WILLIAMSON COUNTY, TEXAS CHANGE ORDER NUMBER: 2

HNTB Corporation
Round Rock
Great Oaks WL

1. CONTRACTOR: QA Construction Services Inc.		Project: Relocation
2. Change Order Work Limits: Sta. 502+25 to	Sta. 512+27	Roadway:
3. Type of Change(on federal-aid non-exempt projects):	Minor (Major/Minor)	CSJ Number: 3185

Great Oaks Waterline Relocation Williamson County Project No. 3185

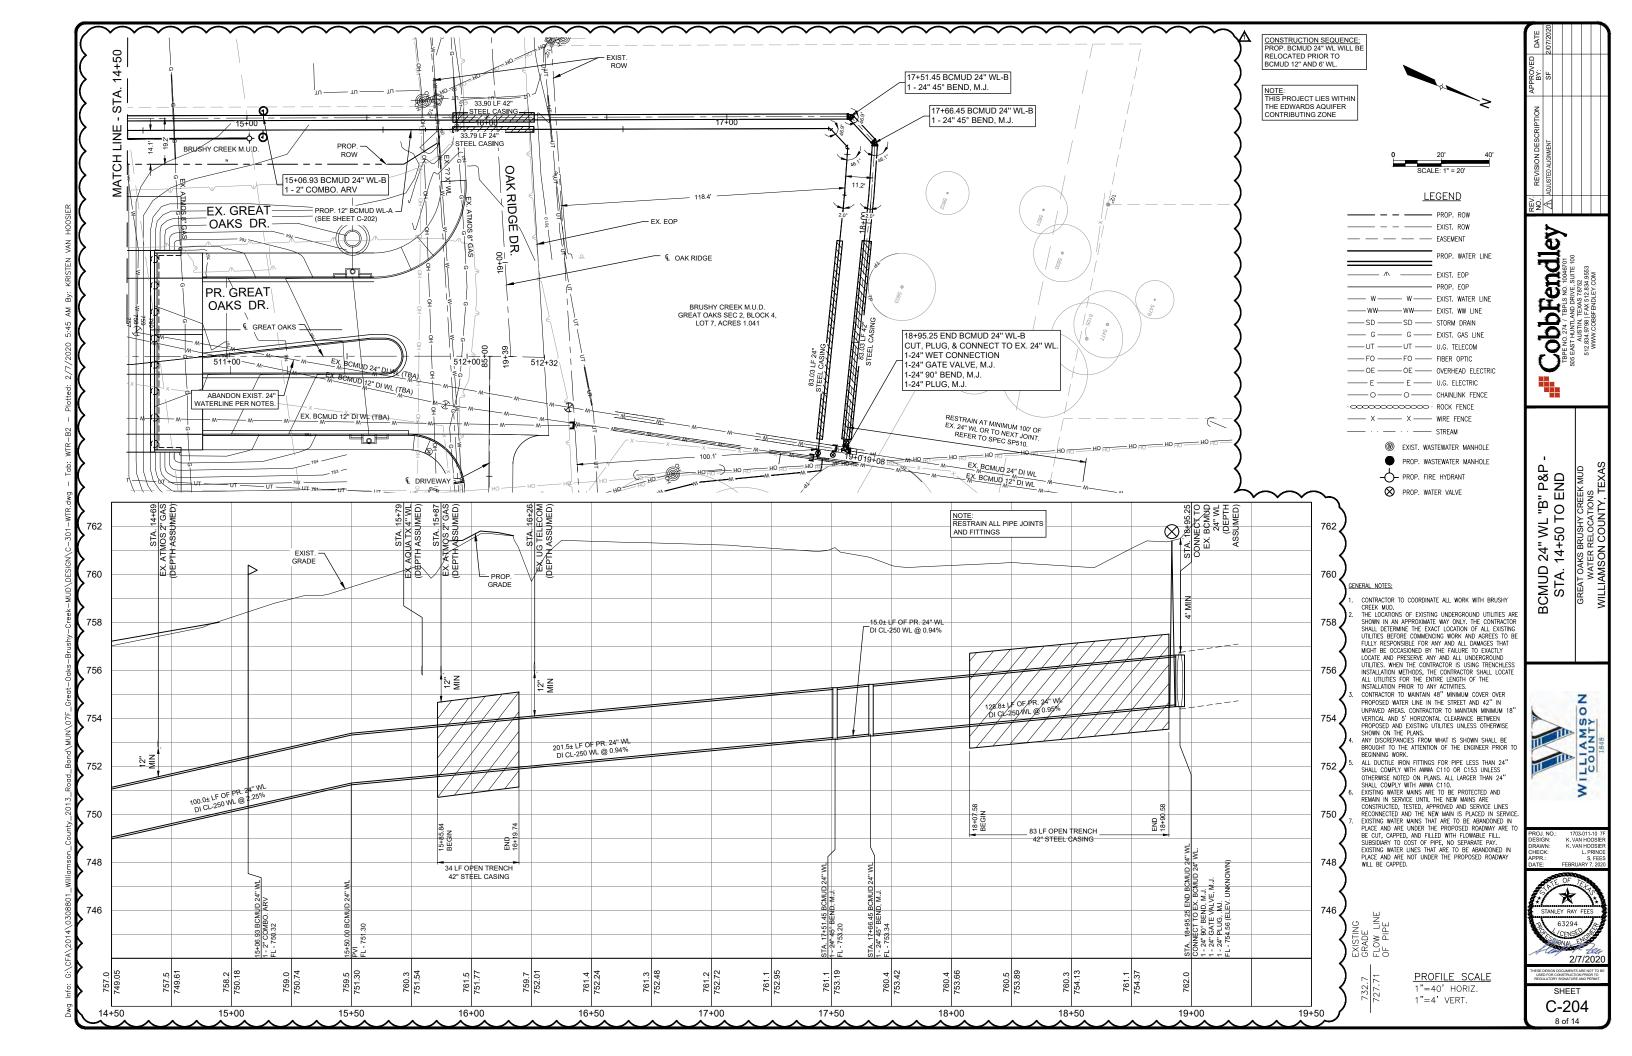
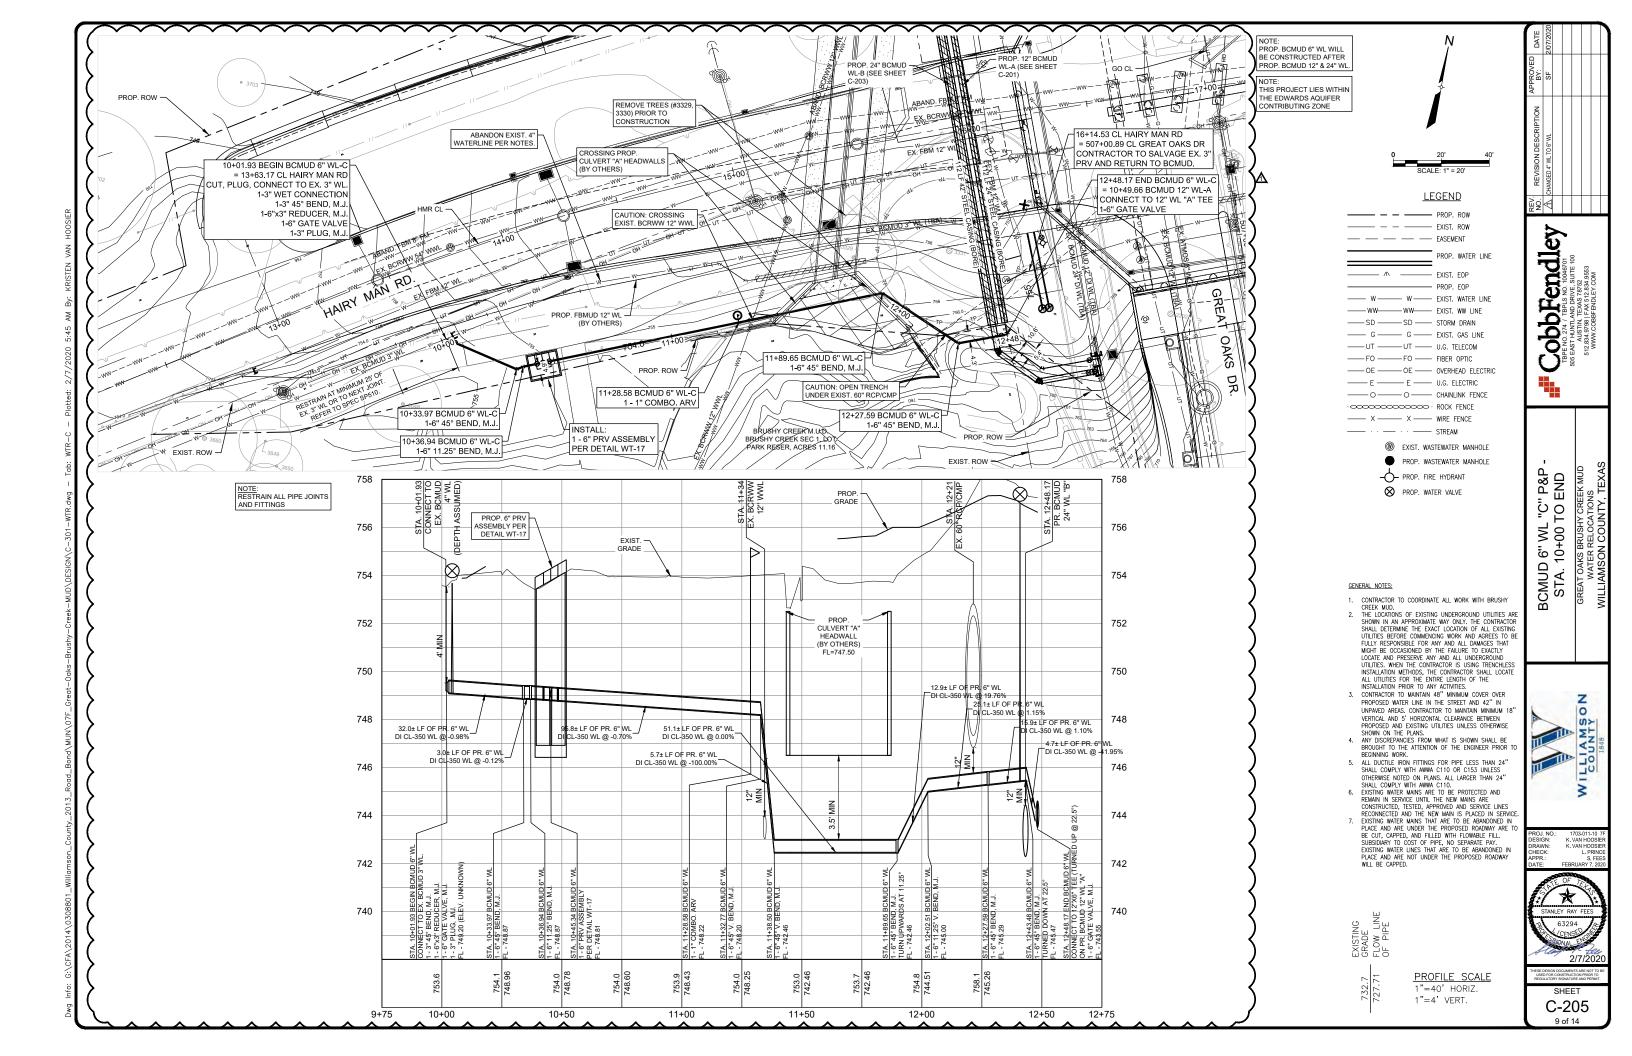
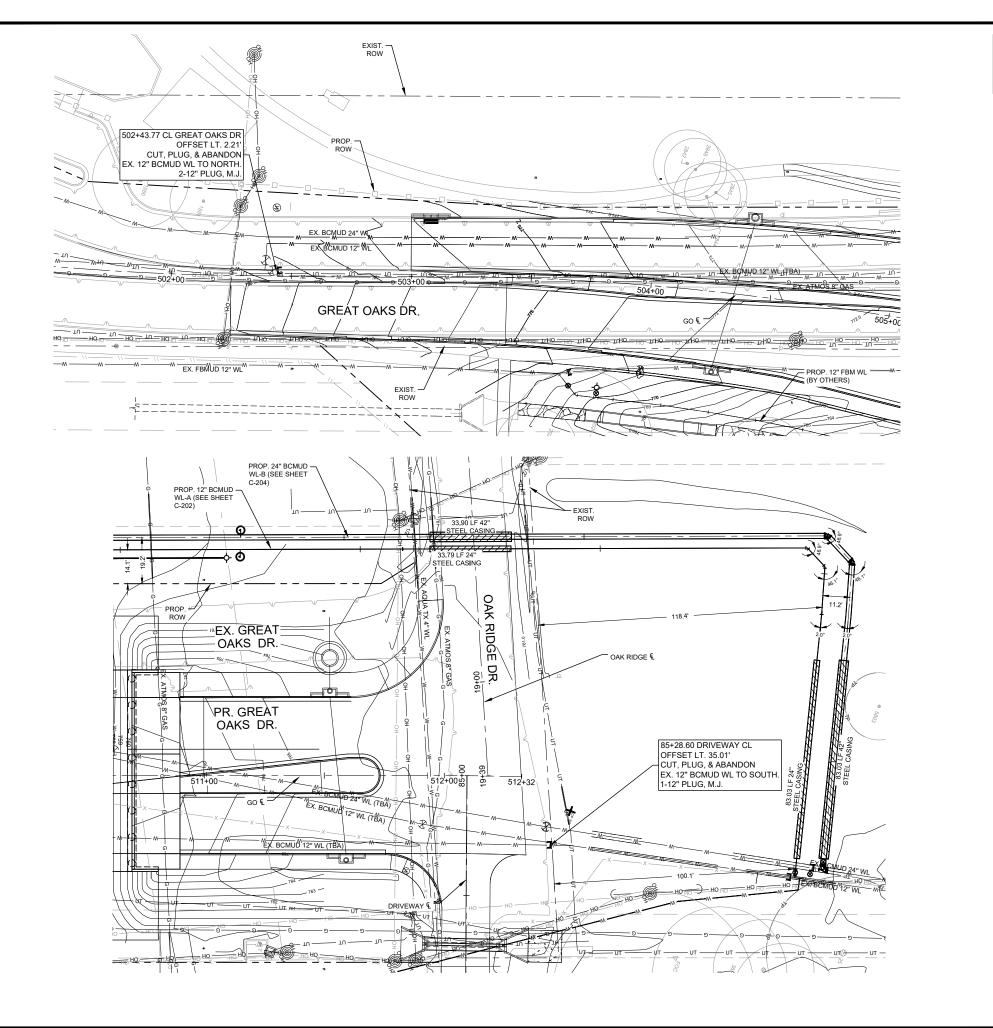
CONSTRUCTION SEQUENCE: PROP. BCMUD 24" WL WILL BE RELOCATED PRIOR TO BCMUD 12" AND 6" WL.

CONSTRUCTION SEQUENCE: PROP. BCMUD 24" WL WILL BE RELOCATED PRIOR TO BCMUD 12" AND 4" WL. THIS BCMUD 12" WL ABANDONMENT WORK WILL BE DONE AFTER THE RELOCATIONS ARE COMPLETE.
